THE REGIONAL MUNICIPALITY OF YORK

ADDENDUM # 4

BID # RFTC-709-23-22021

FOR: Construction of the Warehouse Upgrades at 145 Harry Walker Pkwy

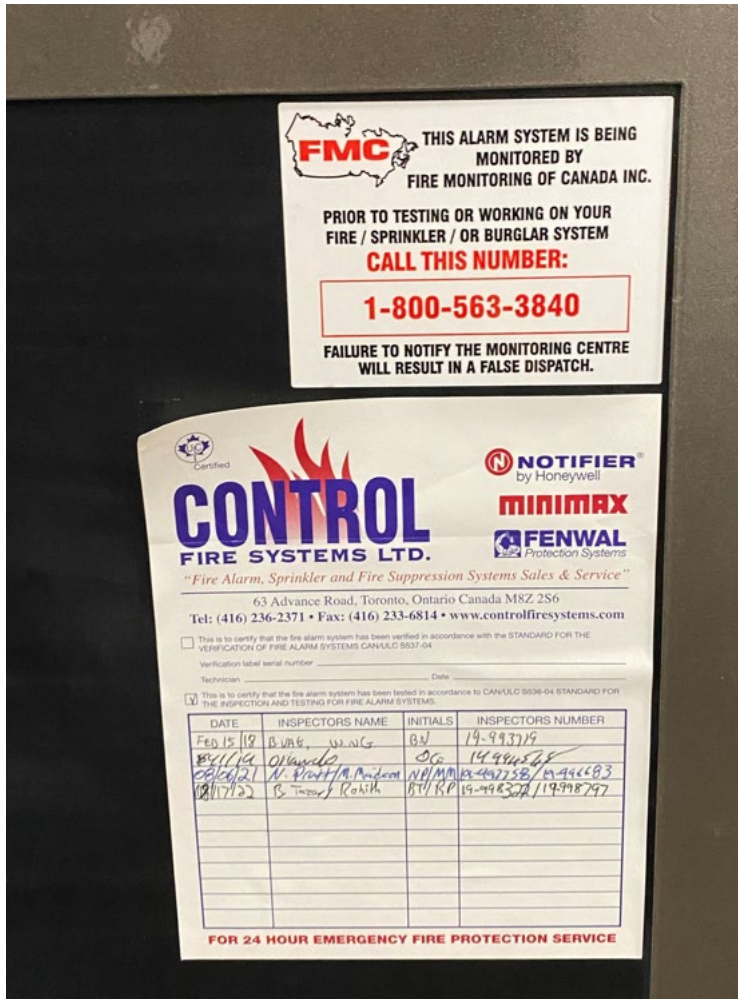
Can you please send the following questions to the consultants for clarification.

- a. Please confirm if we are to provide the following exit signs which show on drawing E201 and E203 if so please provide spec/make/model information.
- b. Drawing E201 shows fixtures that are tagged FB1. Please confirm if these are fixtures or floor boxes in this area. If fixtures please provide spec/make/model.
- c. Please provide a base build communication contact if one is available, if not who is to provide the cable tray on drawing E108.
- d. Please provide base building fire alarm contractor.
- e. Who is to provide all the High Voltage equipment, cabling. electrical contractor or the client will get the utility company.

- Form of Contract - Cabling and wiring for voice and data.
- d. The general contractor can have any certified and competent sub-contractor to work the base building sprinkler system and the fire alarm system. The existing fire alarm monitoring and servicing company as shown in photo below.
